AESO Rule 6.6 Recommendation Update Paper
Stakeholder Comment Response Matrix
March 24, 2009

1. Steady state compliance is based on the unit integrated average MW output for each clock 10 minute period

Chart 1: Deviations from the dispatch level for the Red and Blue Units and the Red Unit’s 10-minute, fixed-interval average deviations. (The values are illustrative only and not intended to relate to the final rule.)

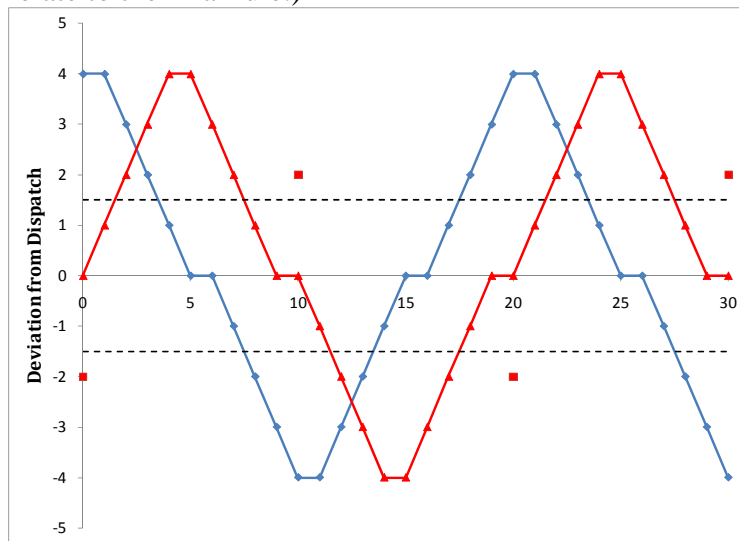
A simple moving average is a particular type of digital filter. Various digital filter design techniques can be used to create other filters (essentially *weighted* moving averages) that may be better suited to the detection of dispatch variances and the avoidance of “false positives.” ENMAX would be happy to discuss these with the AESO and other stakeholders. (Given the rather technical nature of the design techniques, this comment matrix is not the right forum for such a discussion.)

If lose an 80 MW mill.....need a process to inform without provided

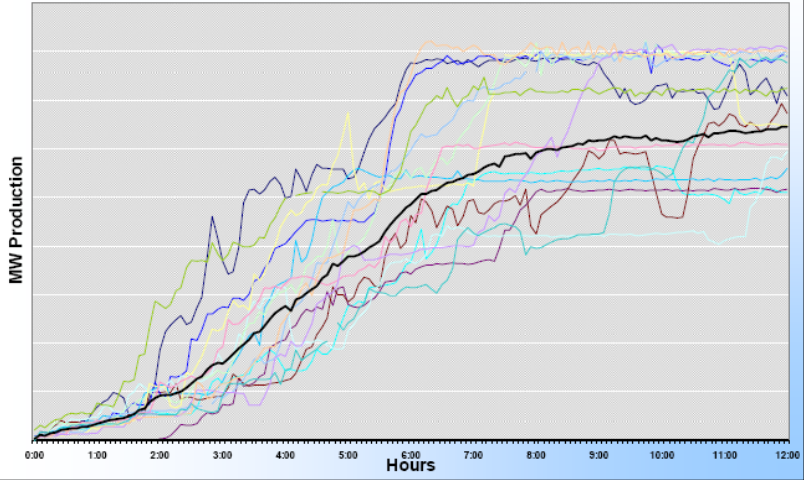
When we have a mill trip it would be typical to see an 80 MW drop in the facility. When this occurs the 10 minute proposed time clock period would still view this facility outside of compliance. It may take some time to determine what is wrong and/or attempt to return to the dispatch. At this point the operator is trying to stabilize the unit. The operator can tell the AESO, or the AESO can tell itself what the current actual generation is. What can't be determined is the facility's new capability without time to determine the problem and the necessary fix. The rule also must incorporate time or allowance for the steps below which an operator takes in assessing the unit's new capability. Once an operator has established that there is an issue with the facility (this alone can take 5mins or more), an operator must:

- 1) Communicate to plant staff to investigate perceived problem
- 2) Wait for results of plant staff investigation
- 3) Calculate new ramp rate given estimated maintenance time
- 4) Communicate to trading or operations desk
- 5) Communicate with AESO

We believe the AESO needs to make allowances in the rule for this circumstance. We would suggest that the generator must restate the facility once it has enough information to know the new capability. We respect and support the system operator's need for the best available information but also need the AESO to understand that sometimes it takes time to provide this information. We cannot provide information we do not have.
